Name: Refrigeration Industries – SPR /Re-Sub /Rev. Perm-SE Corner Foresight & Blichman

TITLE HEADING: Site Plan Review -
New Office/Warehouse

**#207-94 Site Plan Review/Resubdivision and Revocable Permit - Refrigeration Industries
COMMUNITY DEVELOPMENT DEPARTMENT COMMENTS**

PARKING LOT LIGHTING

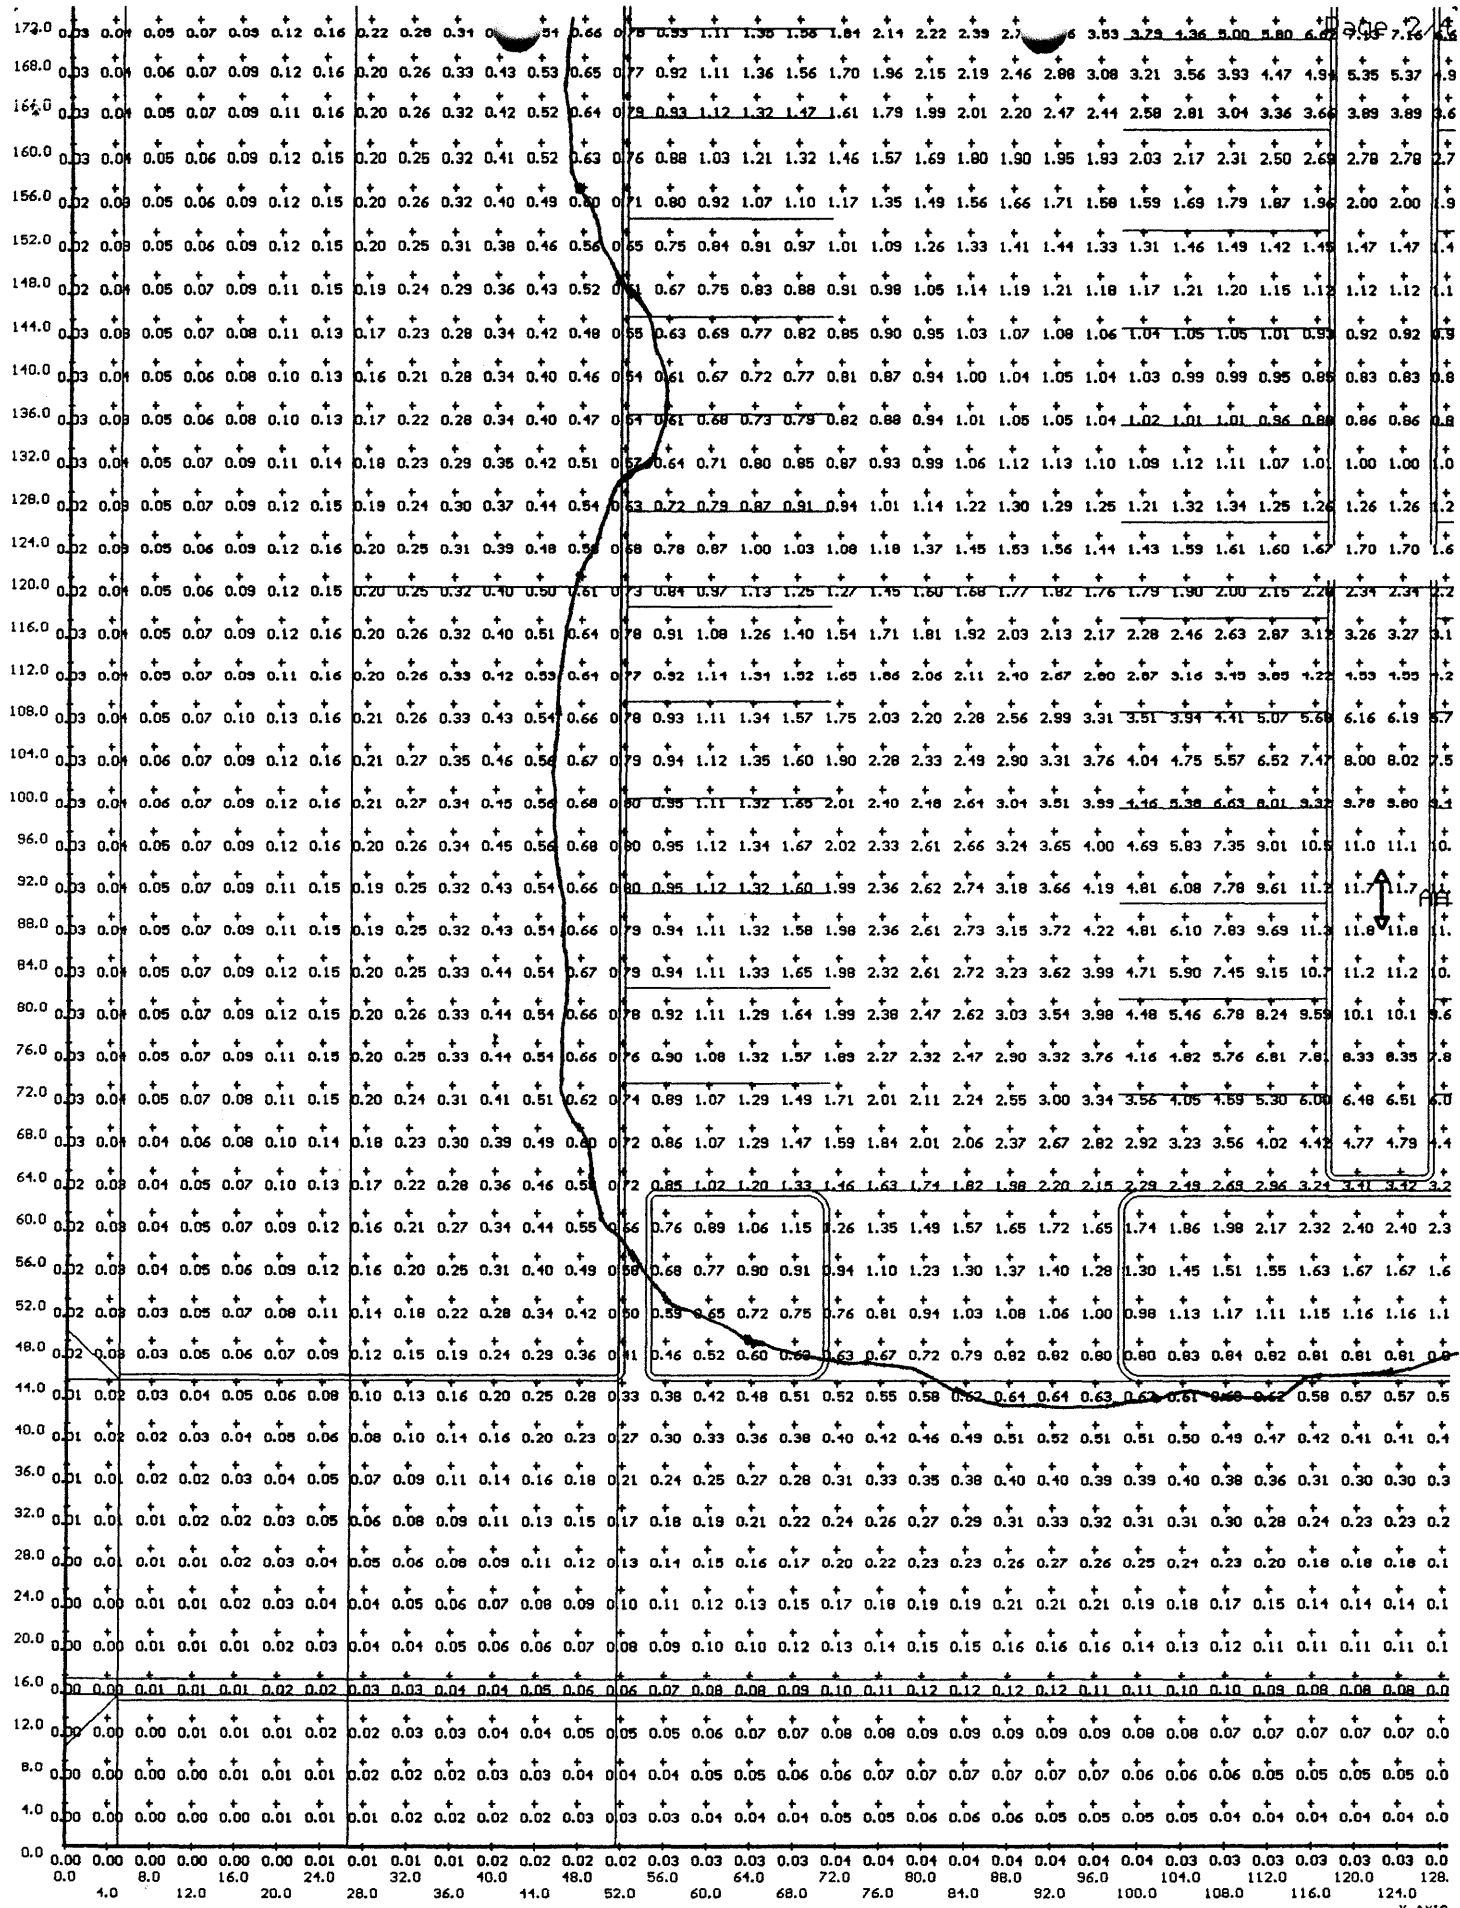
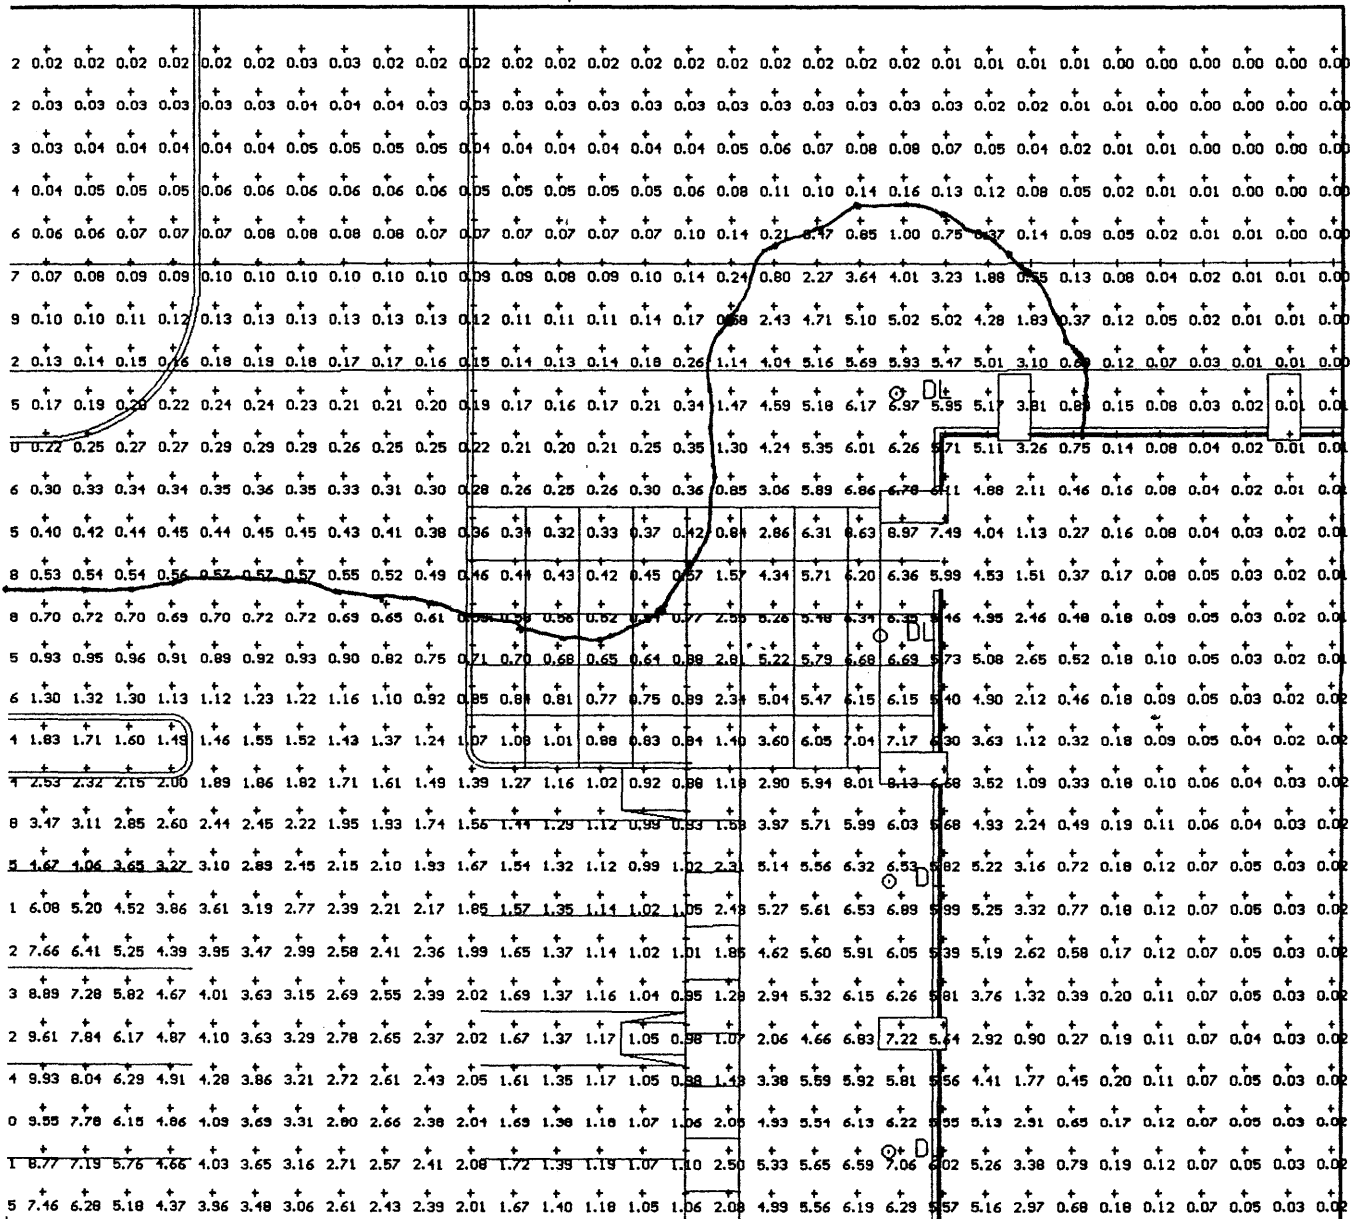
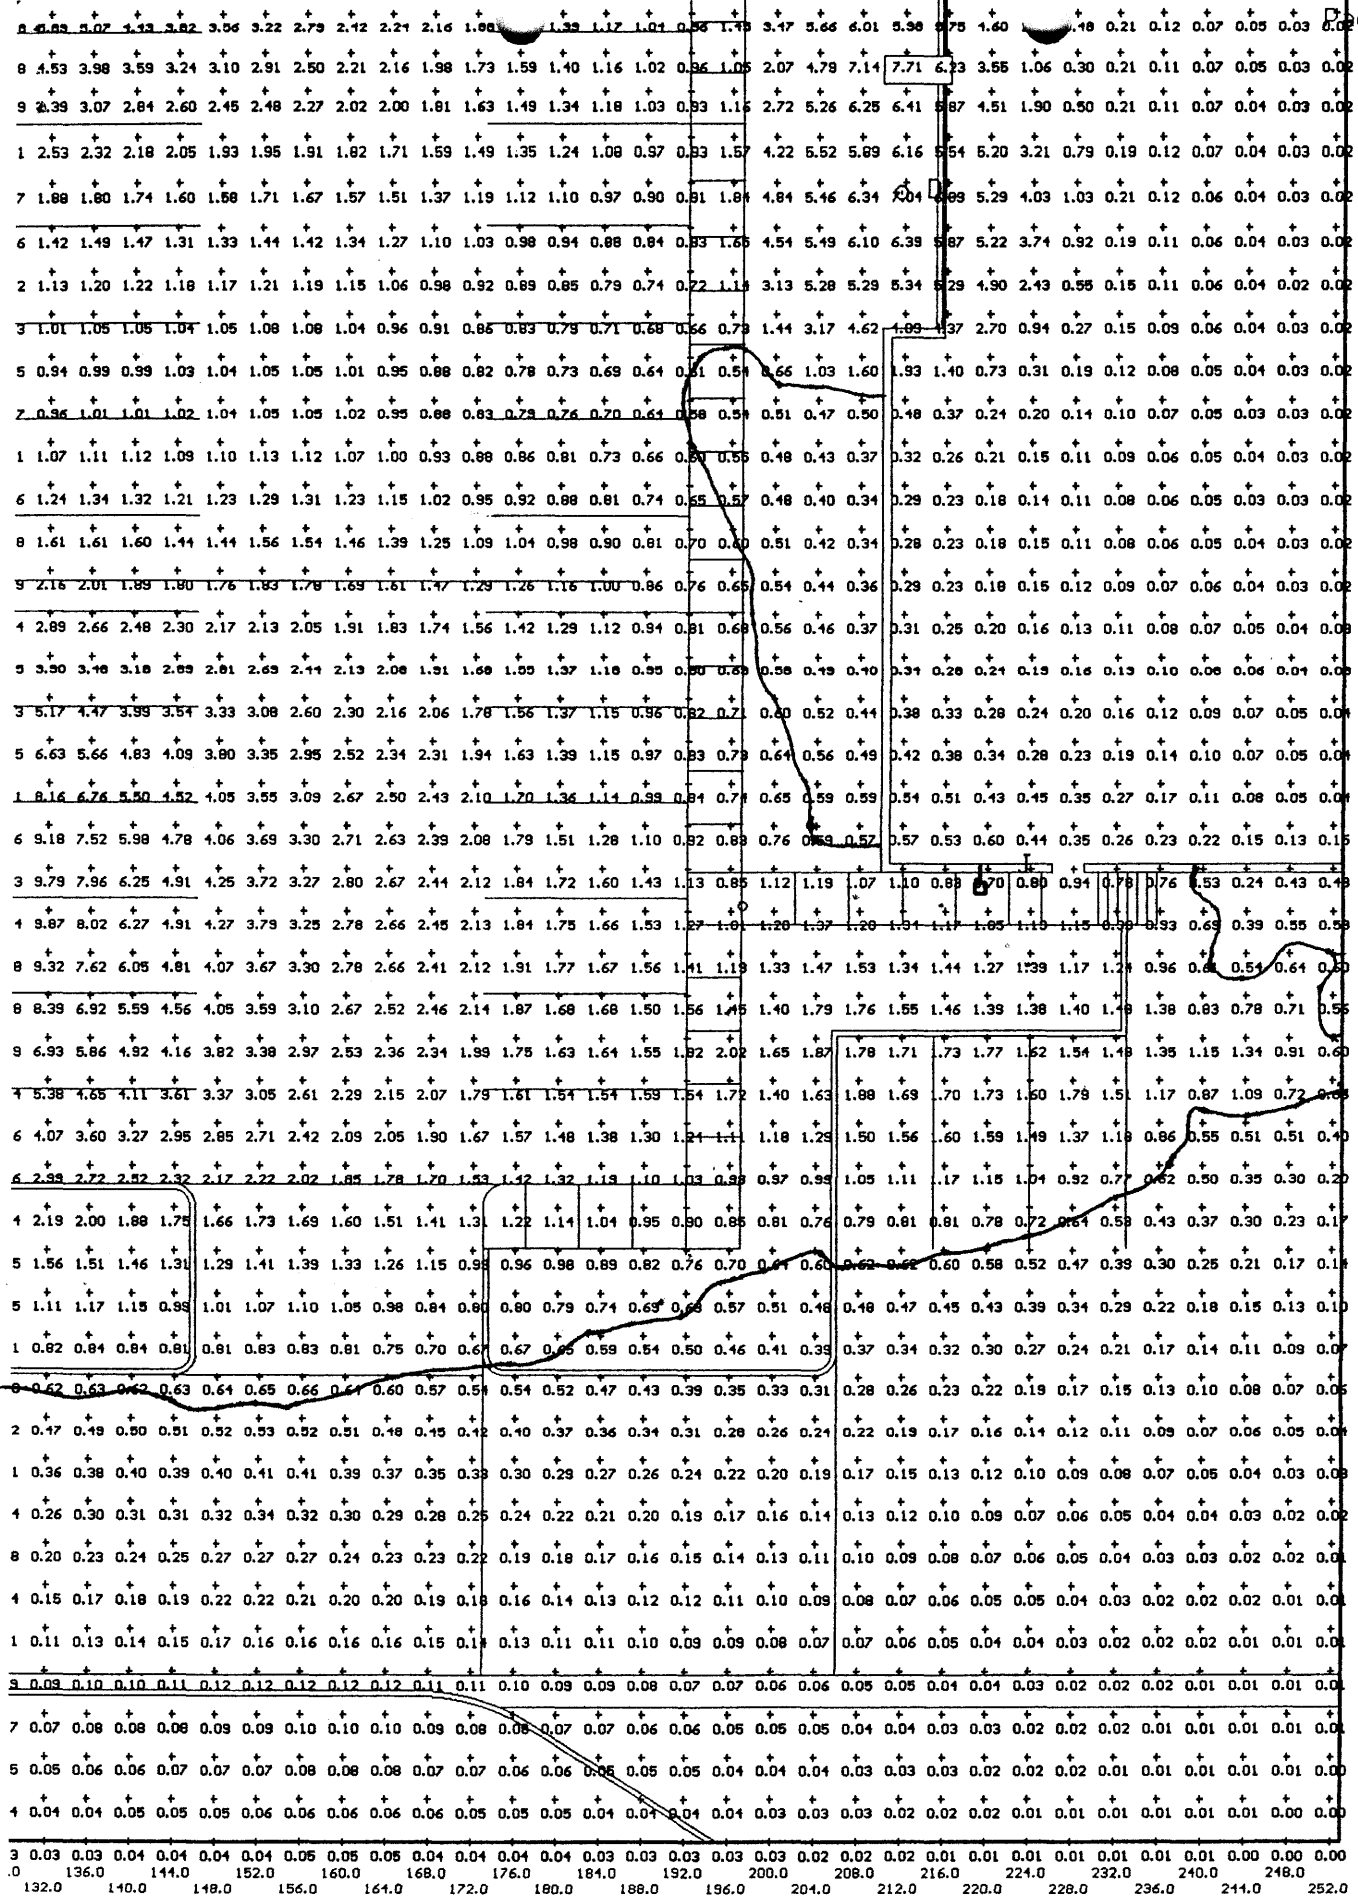
Site Plan - See attached checklist. Three handicap spaces are required and must meet dimensioning, signing and marking standards. No parking lot lighting is indicated on the Site plan. Asphalt and concrete pavement sections need to be included in details and should reflect the recommendations of the soils report. The driveway radii may need to be increased depending on the size of trucks anticipated to be using this site.

1. See attached set of drawings for accessibility, paving sections and details. The electrical drawings indicate parking lot lighting. Small trucks and vans are primary delivery vehicles.
2. See Sheet C2 for grading which reflects design indicated in the drainage report. The plan shows grades which direct water to the Detention Area. The grades were designed to hold the volumes indicated in the drainage report.
3. See Sheet L1 for plant types.

MINIMUM PARKING LOT SECTION

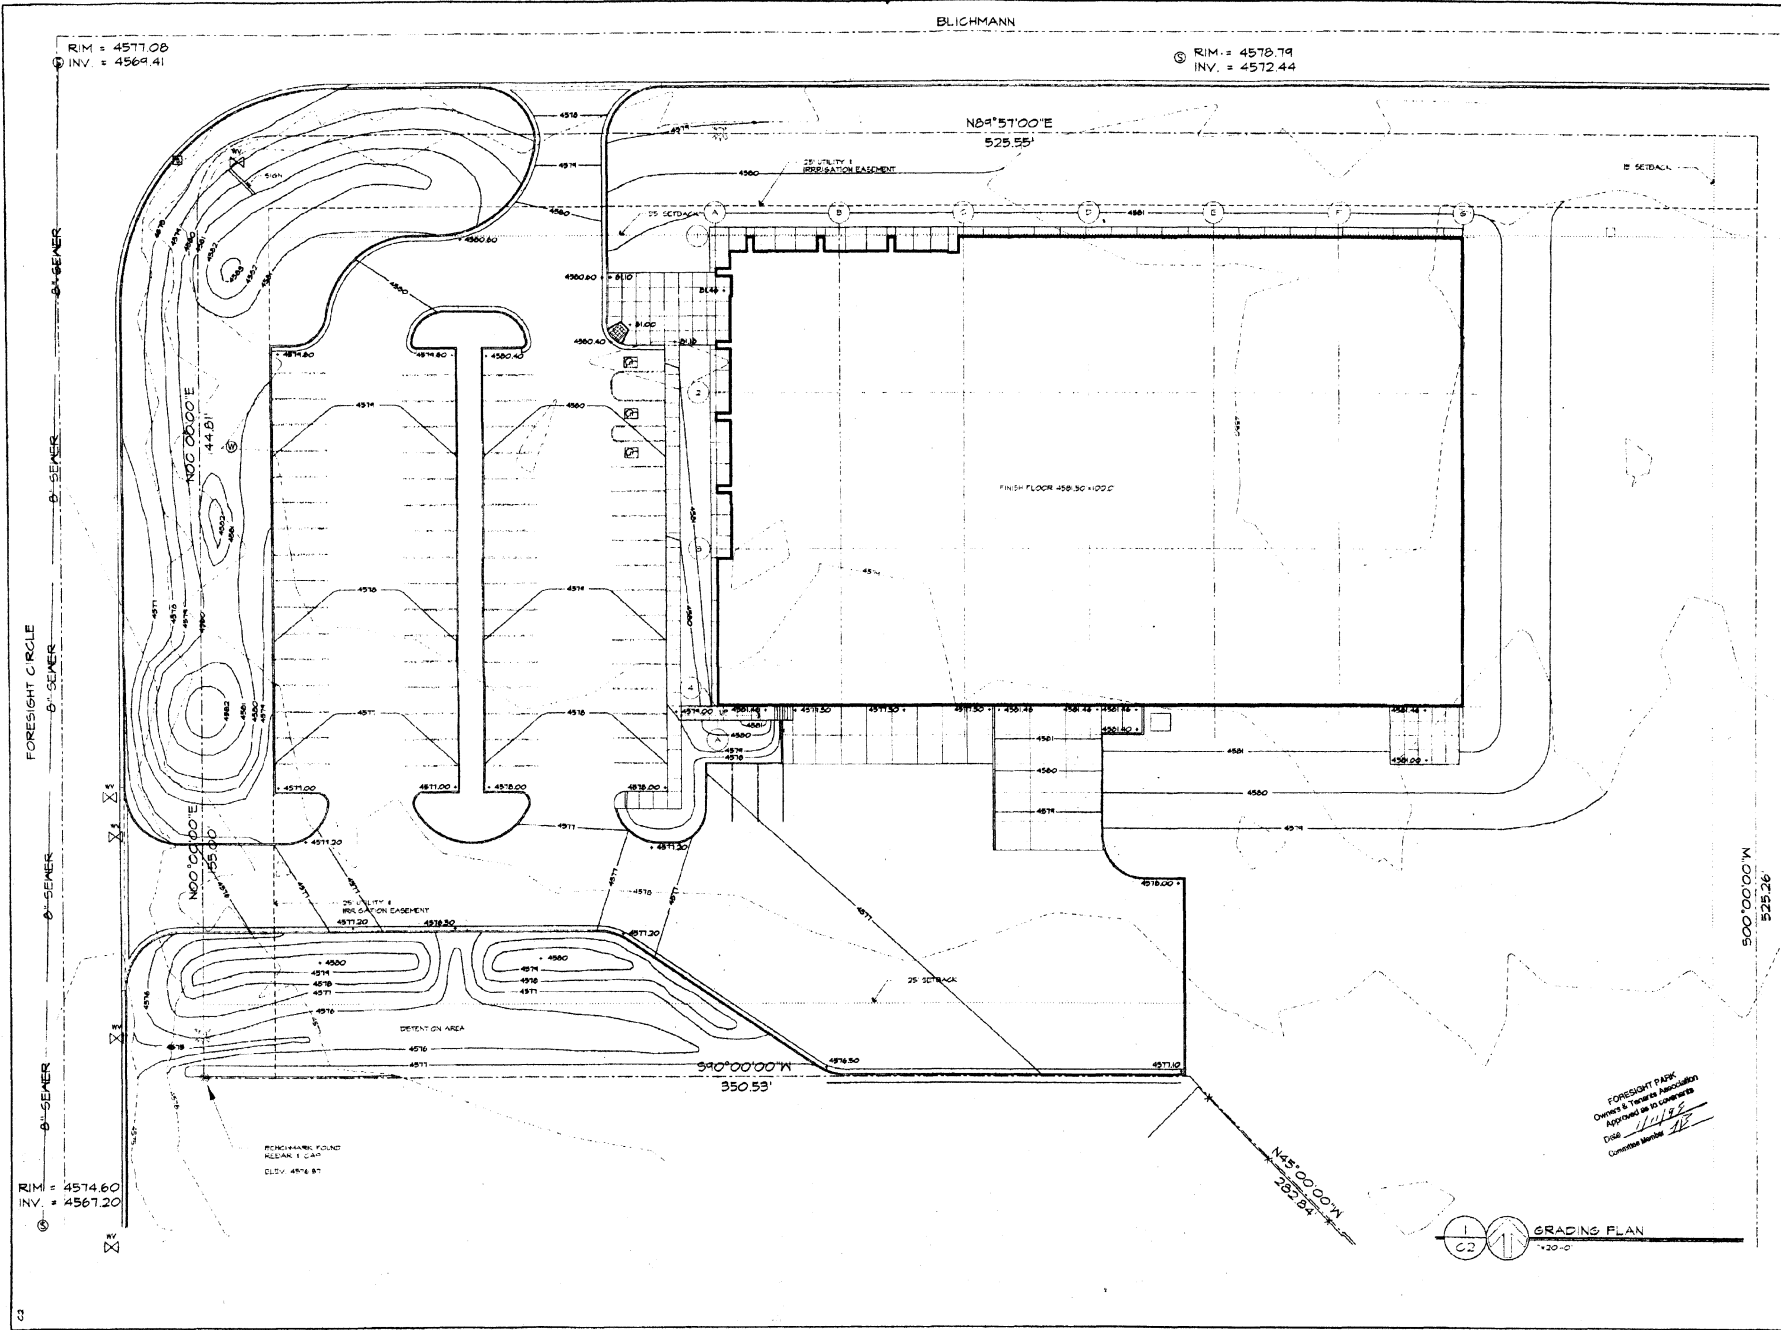
4. Section 5-5-1F2c(2) requires a 2 1/2 foot overhang be provided in planting areas where bumper or door overhang are anticipated. The overhang may be constructed of concrete or paving blocks, asphalt paving is not permitted.

1. The "minimum parking lot section" as detailed on Attachment "A" in the response to comments which includes the paved overhang will be required as per Code.
2. A note shall be added to the shrubs identified on the plant list in the Landscape Plan indicating a five gallon minimum size for all shrubs.
3. The location of the bicycle rack shall be indicated on the Site Plan.
4. The items circled on the attached Site Plan Drawing Standards Checklist need to be shown on the Site Plan or provided in writing (as indicated).

1. See attached Drawing C1.1 which indicates the required paved area at the parking lot median. This drawing will be included as part of an addendum to the contract documents.
2. See attached Drawing L1.1 which indicates the five gallon minimum shrub size. This drawing will be included as part of an addendum to the contract documents.
3. See attached Drawing C1.1 which indicates the bicycle rack location near the intersection of Grids B and 4.
4. Utilities shall be supplied by the following:
Gas and Electricity: Public Service
Irrigation Water: Foresight Owner's and Tenant's Association
Domestic Water: Ute Water
